Precinct Structure Plan Response

Croskell Precinct Structure Plan

Date	9 October 2024
Project No.	24030 00 v1.0
Author	Jamie Tainton
Client	Wolfdene c/o Marshal

Figure 1: Proposed Drainage Scheme (Scenario 3)

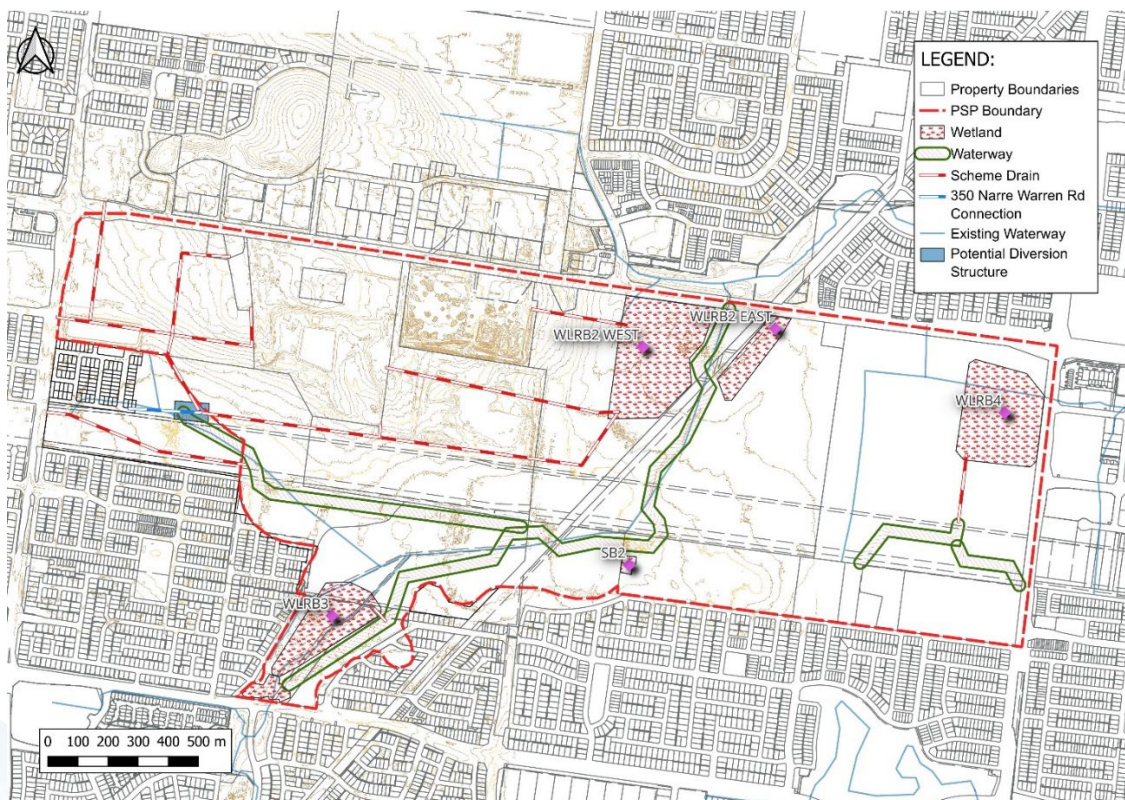
- To remove the overland flow path above pipeline E in lieu of upgrading the pipeline to a 1% pipe. This will require a diversion structure or basin of some kind to appropriately manage the flows.
- Water Quality should be managed across the PSP area in locations that suit the topography and relevant authority requirements.
- We also recommend the design, costing and blending of integrated water management infrastructure into the DCP/ICP as shared cost items.
- Interim solutions are an essential part of development and need to be available for negotiation. Full downstream construction of assets would certainly impose impossible barriers to development.

Figure 4: Plan 7 – Public Realm and Water

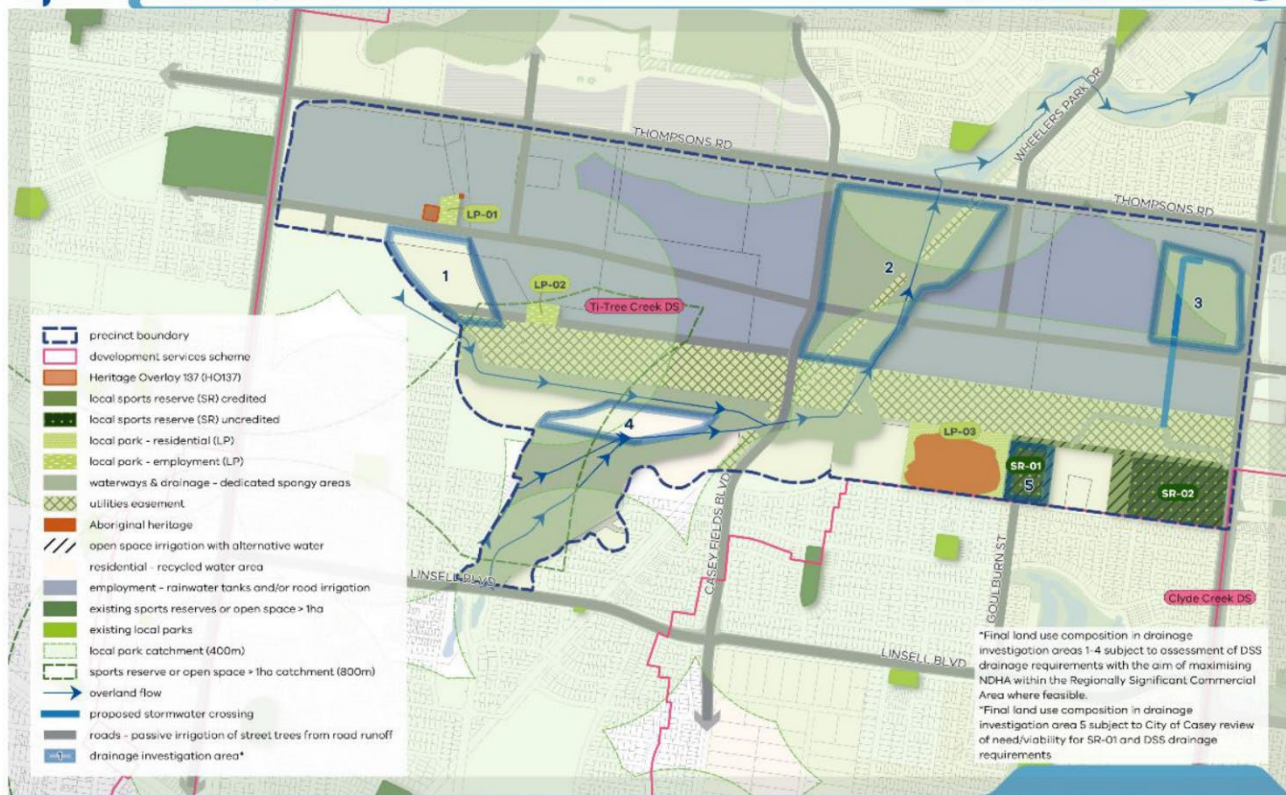
The PSP should look for opportunities for shared stormwater harvesting, infiltration sponges and passive irrigation. In Plan 7 (as shown in Figure 4 earlier in this document) several initiatives have been outlined that will work towards meeting these targets. There is no confirmation that the ideas presented in Plan 7 meet the requirements set out in this publication.

Figure 21: Exhibited Drainage Scheme (Scenario 1)

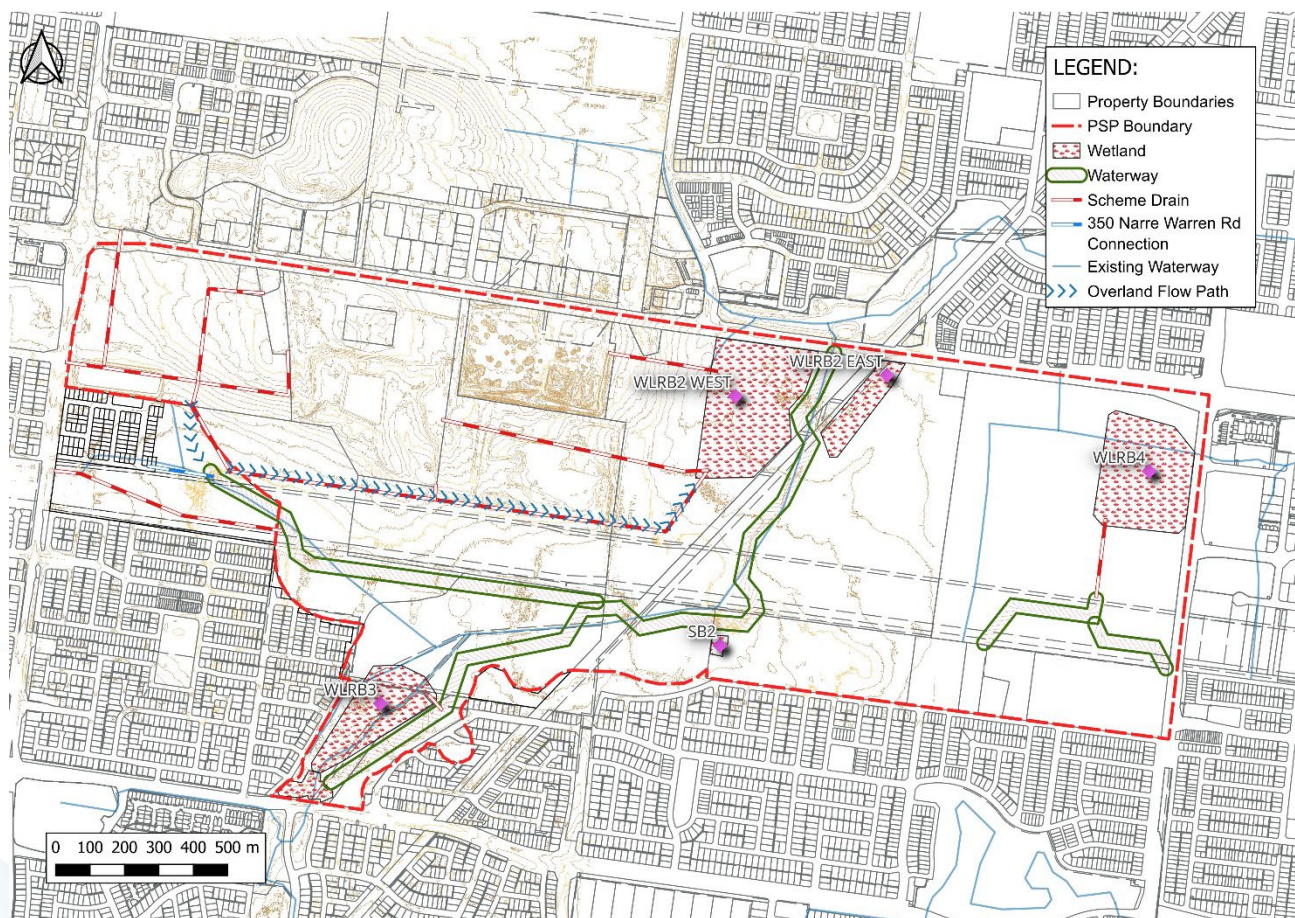
In order to develop this area, formal drainage assets are required to be designed and constructed. MW and the VPA provided details of their preferred solution with an opportunity to explore and discuss it. The proposed drainage layout, as provided by the MW and the VPA can be seen below in Figure 21 and incorporates:

Figure 28: Pipe alignment

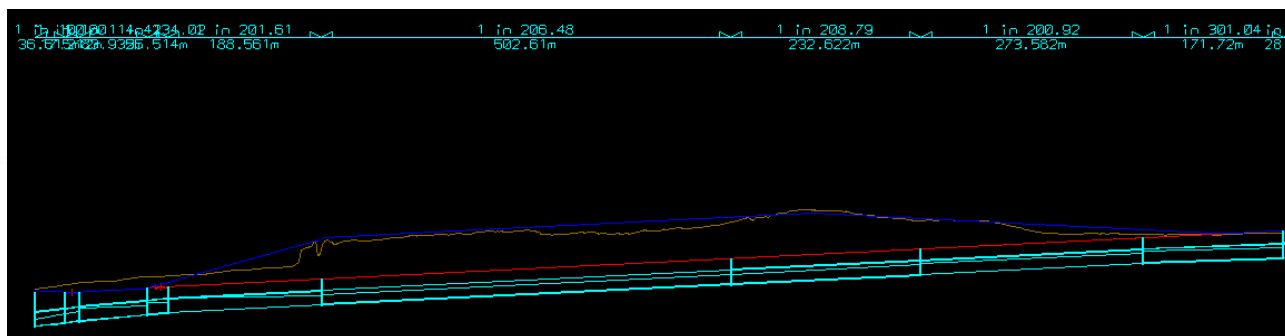
The proposed alignment of the pipe in the longitudinal section shows the extent of cut required to not only install the pipe, but the overland flow path in the form of a road above it. This would mean the road is constructed up to 5m below the natural surface in order to facilitate an outlet. This solution requires at least two 1650mm pipes at over 1.5km based on our design. We have also identified that the road (at 0.5% grade) cannot adequately carry the gap flow and would evidently require more water into the pipe (an additional pipe may be needed).

Figure 29: Future overland flow path PSP Road Section (including pipe and proximity to the VDP cable)

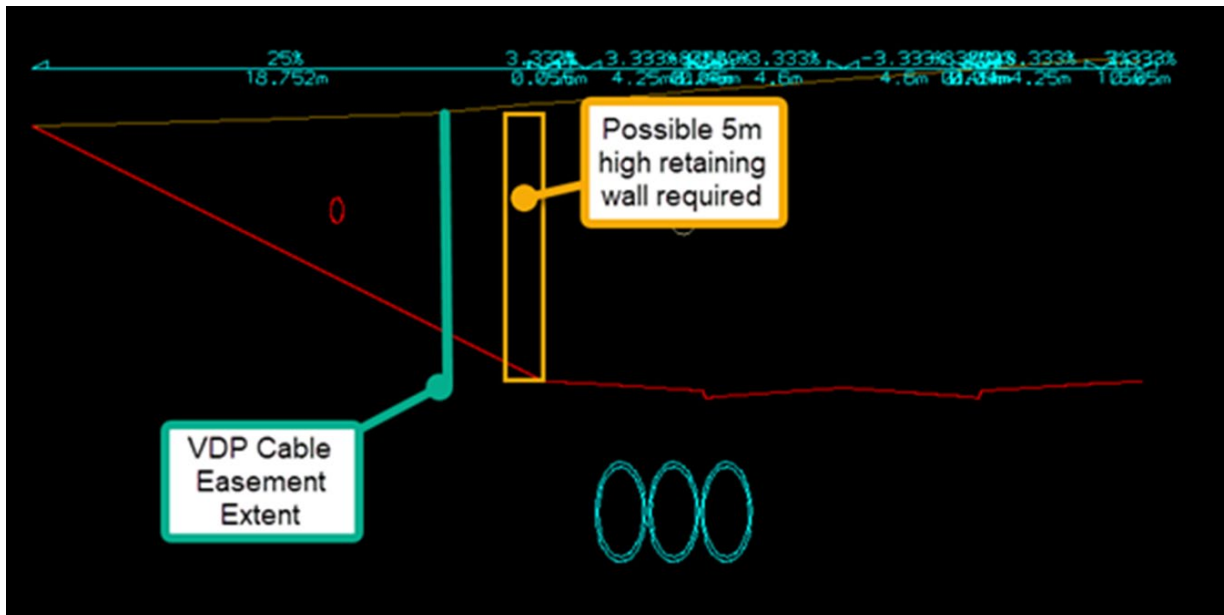
When we look at this in cross-section we can see the real impact of the overall road depth in this solution against the VDP cable (refer to Figure 29). This section of industrial access road acting as the overland flow path over Pipe E would, at its worst point, be up to 5.0m in cut against the VDP cable easement.

Figure 30: Expected length of wall

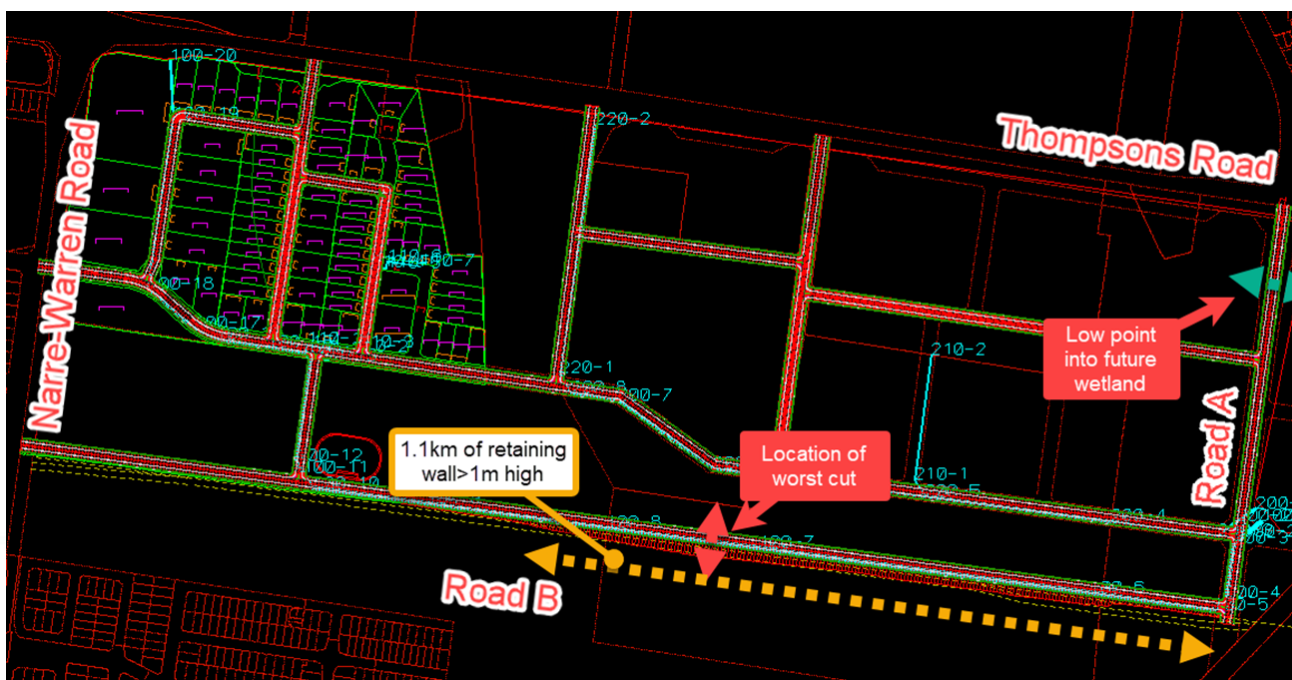
The extent of the wall construction varying from over 1m high (up to 5m high) can be seen in Figure 30 below. As seen, the Exhibited Solution would require the industrial access road acting as the overland flow path to be in excessive cut for a at least a 1.1km continual length against the VDP cable easement.

A 5m high wall along the edge of any road would make access to each parcel extremely difficult and result in the need for ramps and loss of useable space. This could render many parcels or space earmarked for development virtually undevelopable.

Figure 31: Extent of cut (red) and fill (blue)

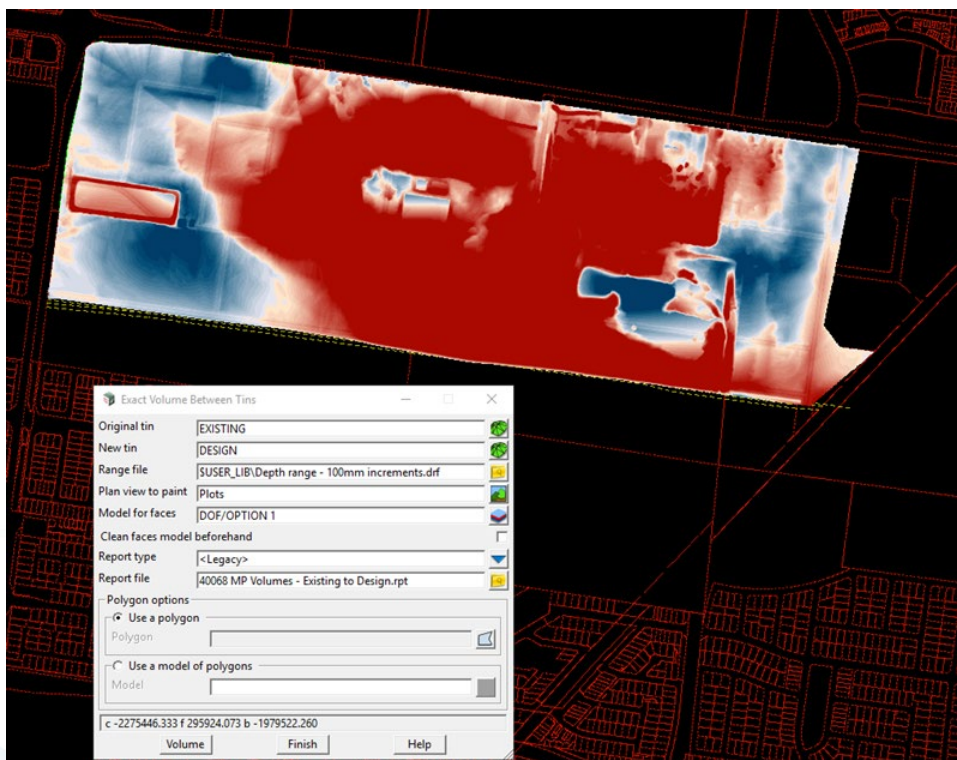
When looking at the earthworks for this Scenarios 1 and 2 in Figure 31, we can see significant cut will be required throughout the area ($>2.2\text{mil m}^3$) and together with the fill, looks like 2.5mil m^3 of earthwork moved around the site (details can be found in Table 9). This excludes the earthworks needed for the large pads expected in an employment area like this.

Figure 32: Proposed Park cuts overland flow path

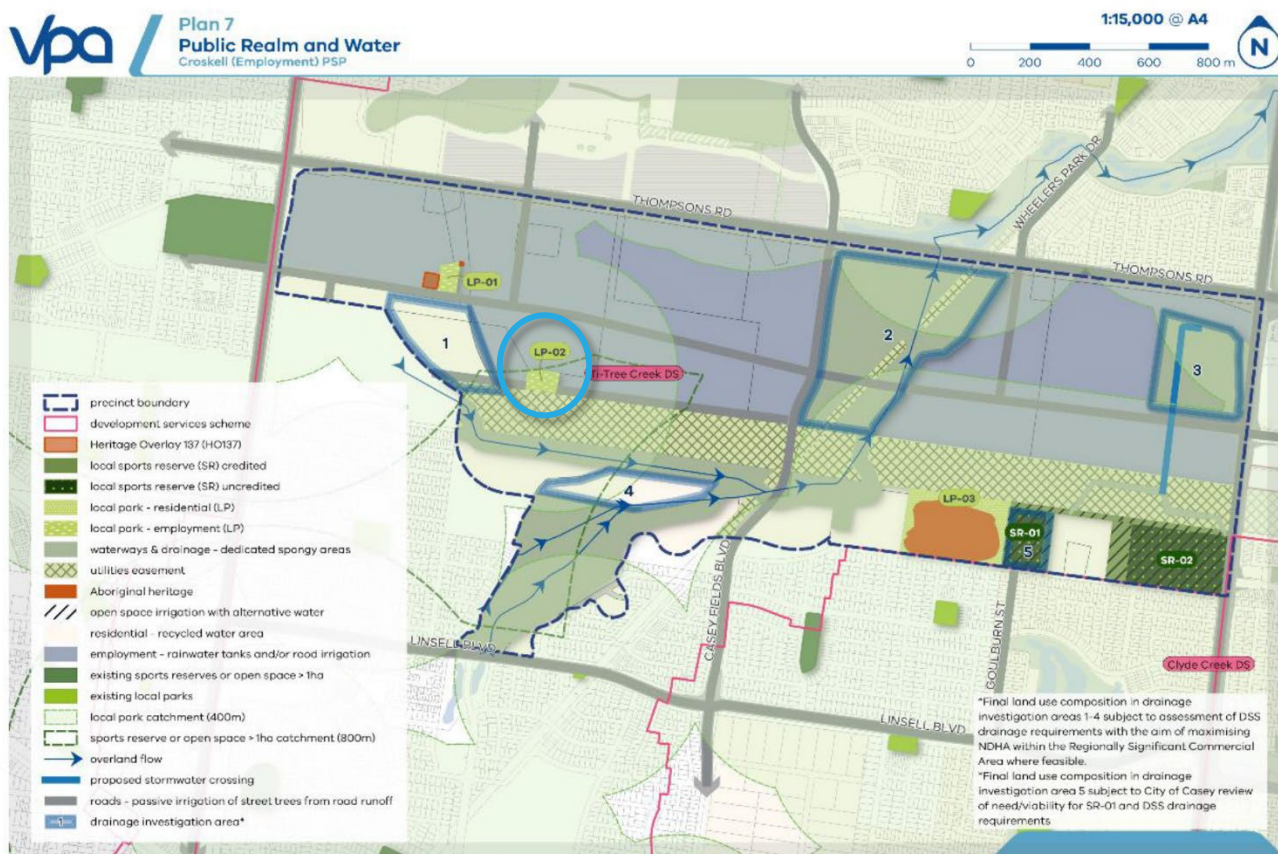
When looking further at the overland flow path along the future local access street above the pipe, we can see in Figure 32 that a local park (LP-02) is proposed part way along its length breaking the “through road” nature. Given the road is going to be 5m+ below the surface and carrying an overland flow path, has the PSP appropriate considered the location of this park? If it were to be located as proposed, 5m+ retaining walls may need to surround the park or perhaps a tiered solution is proposed?

Further consideration needs to be given to the location of the park and overland flow path.

Figure 33: Proposed Drainage Scheme (Scenario 3)

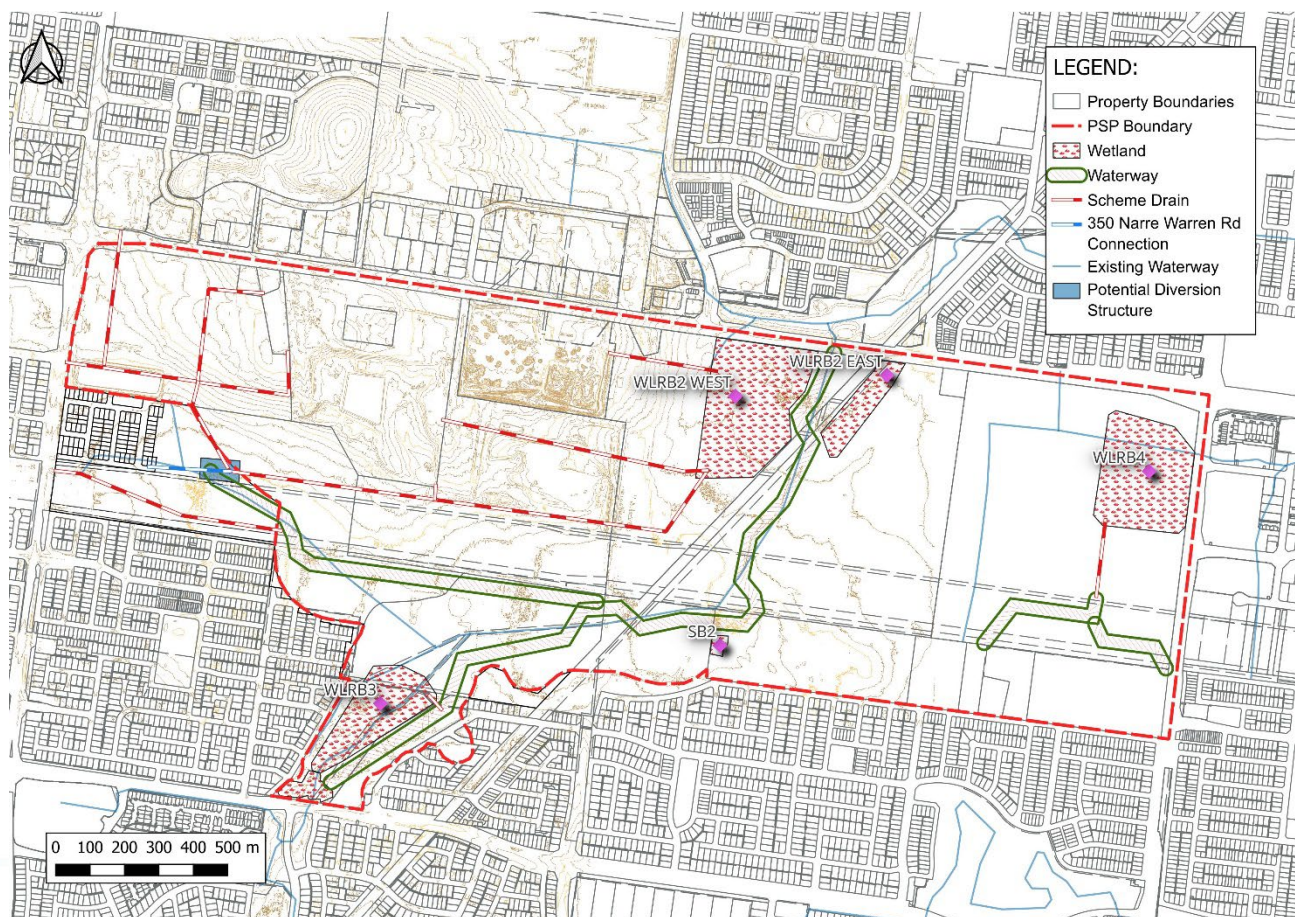
The proposed drainage scheme layout, as adapted from the VPA exhibited solution can be seen below in Figure 33. In this Scenario the blue connecting pipe from the 350 Narre Warren Rd development now connects to the east west pipe. The east west pipe is now proposed to take the entire development in a 1% flow arrangement with no overland flow above Pipe E. A back up grassed swale over the VDP cable is proposed to take flows over and above the 1% and as a backup should the 1% pipe block or fail in anyway.

Figure 35: Pipe alignment

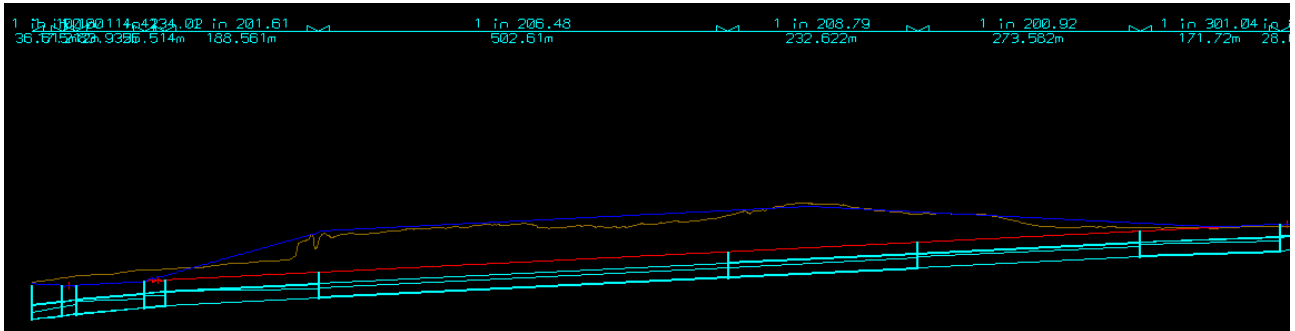
The alignment of the pipe in the longitudinal section in Figure 35 shows the depth of pipe with respect to the proposed road (shown in dark blue) above it. This would mean the pipe is constructed up to 8m below the natural surface in order to facilitate an outlet.

Figure 36: Future overland flow path PSP Road Section (including pipe and proximity to the VDP cable) – Cross-section Cut example

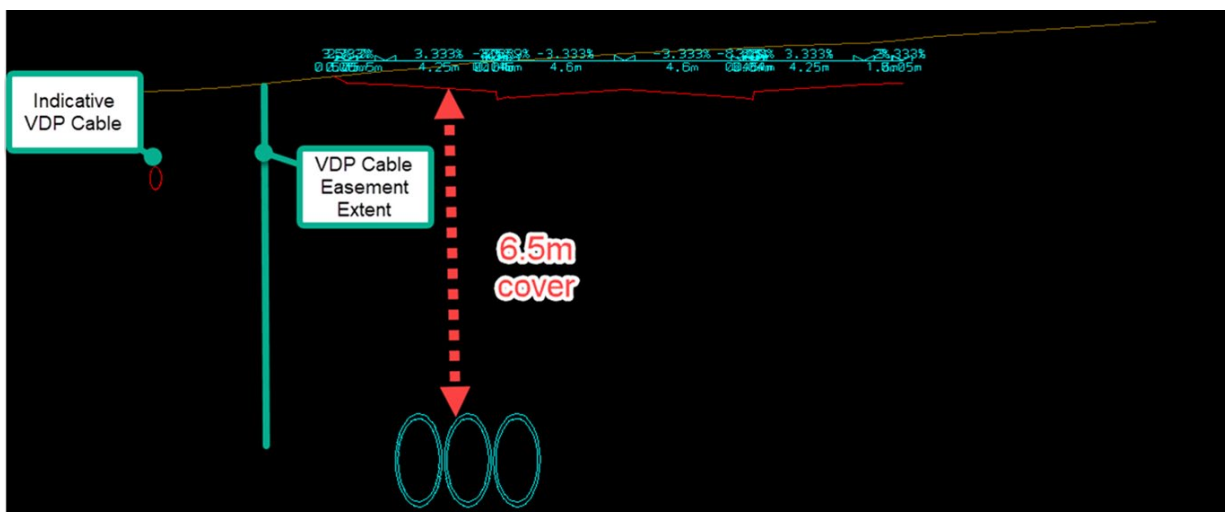
When we look at this in cross-section we can see the impact of the overall pipe depth in this solution (refer to Figure 29). Further to this we recommend shifting the pipes to the northern side (right of the page) of the road to ensure it is beyond the angle of repose to the VDP cable. This would still be within the 50m SCO zone of the cable but enables full use of land in this area with minimal impact to the cable and its heat dissipation zones.
